Groundwater Application Review Summary Form

Application # G- 18588

To: Kristopher Byrd, Well Construction and Compliance Section Manager
From: Joel Jeffery, Well Construction Program Coordinator
Subject: Review of Water Right Application G-18588
Date: September 24, 2018

TO: Water Rights Section Date 6/12/2018
 FROM: Groundwater Section Benjamin Scandella, Dennis Orłowski
 Reviewer's Name
 SUBJECT: Application G- 18588 Supersedes review of _____
 Date of Review(s)

Water level trends from wells within approximately 2.5 miles of the applicant's well that obtain water from the sedimentary aquifer system, as well as the nearest sedimentary well with a long-term continuing trend (COLU 3379, over 10 miles north).

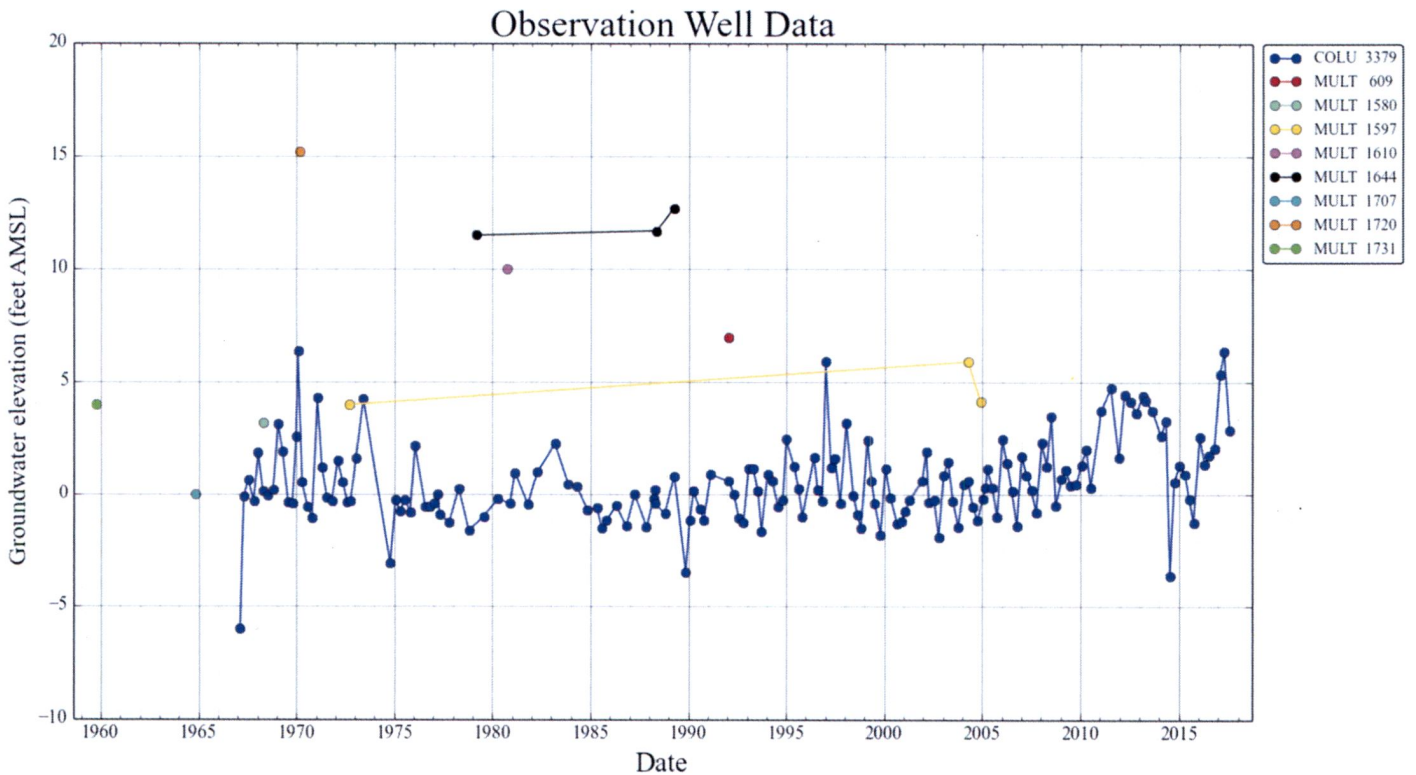
Groundwater is likely available and not over-appropriated in this area due to the large storage capacity and permeability of the aquifer materials (primarily sand and gravel) and the high rate of recharge (Conlon and others, 2005). Recharge in this unconfined USA system comes from both precipitation and nearby surface water, especially due to the proximity and efficient hydraulic connection to the Multnomah Channel. While groundwater level data for aquifer wells in the area is not available over long periods to definitively determine the current state of the groundwater resource, the nearest well showing long-term data in the sedimentary aquifer system (COLU 3379, more than 10 miles to the north) is also probably hydraulically well-connected with local surface water and shows relative long-term stability for the past 50 years. Despite this conclusion, and because local groundwater data is nearly non-existent, the permit conditions noted in B1(d)(i) are recommended to provide additional information to support future understanding and management of the groundwater resource in this area. If the applicants provide the well log or a well inspection report for Well #2 confirming that it is open to the same aquifer system as the other 3 wells (pending approval from an OWRD hydrogeologist), then due to the high transmissivity of the aquifer system and the close proximity and similar completion of all the wells, it would be sufficient to provide annual water level measurements from any 1 of the 4 wells.

- i. The permit should contain condition #(s) **7n (annual meas.), large water-used reporting**;
 - ii. The permit should be conditioned as indicated in item 2 below.

Well location map, G-18588 (Portland Metro). T2N/R1W - S21

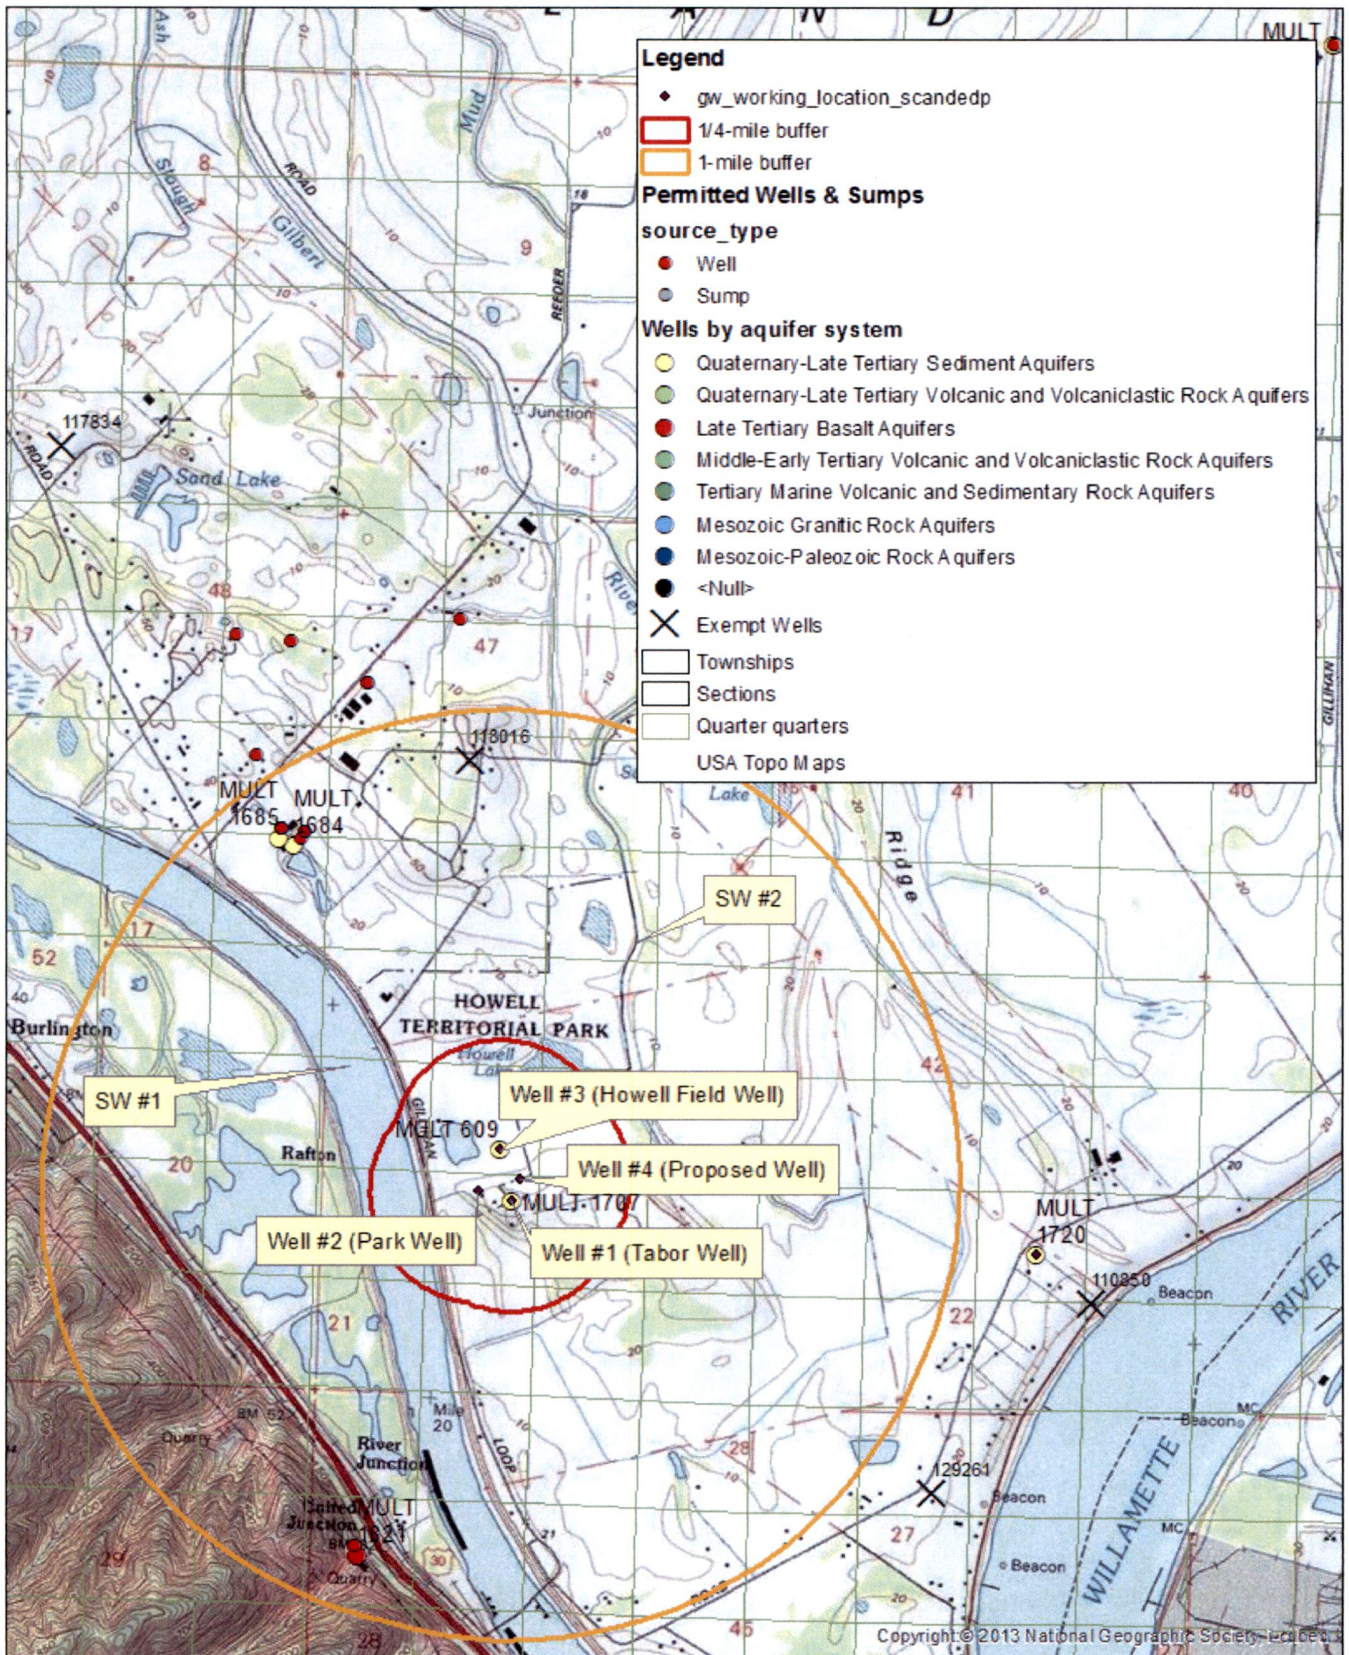
- A4. **Comments:** The applicant's wells are located near the south end of Sauvie Island and on the western side, approximately 2 miles downstream from where the Multnomah Channel diverges from the Willamette River. A well log for Well #2 was neither provided by the applicant nor found in the OWRD well log database matching the information given. The well logs for Wells #1 and #3 show similar geologic material, so for the purpose of this review, Well #2 is assumed to have been drilled through similar geologic material and be open to the sand and gravel layers 60-90' below land surface. The proposed well (#4) should also obtain groundwater from the Unconsolidated Sedimentary Aquifer (USA) (Swanson and others, 1993).
